M2M Doc.#1901050

GM 6.0L Power Steering Active Hydraulic Assist (NV8) Module Relocation

Underhood 70 (V900127)

2012-2017 GM 2500-3500 6.0L V8 Gas

Figure. 1

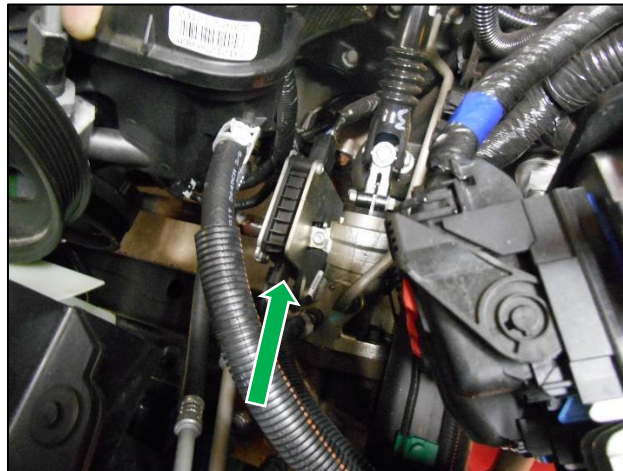
GM trucks with 6.0L gas engine, equipped with Power Steering Active Hydraulic Assist (RPO code NV8) include an installed module that will contact the power steering fluid reservoir when the engine rocks during acceleration, after the installation of a V900127 kit.

This contact will result in power steering fluid leakage from the reservoir and loss of power steering.

- Inspect for a Power Steering Module (see Figure 1) or, if the truck has not yet been delivered, obtain a VIN and Contact your GM dealer to determine if RPO code NV8 applies to that truck.
- If RPO Code NV8 is present, the truck is equipped with Power Steering Active Hydraulic Assist, and the module will require repositioning.
- Order A900017 Accessory Kit through regular VMAC parts channels. This installation will reposition the Power Steering Module to create sufficient clearance between the module and power steering reservoir to prevent contact.
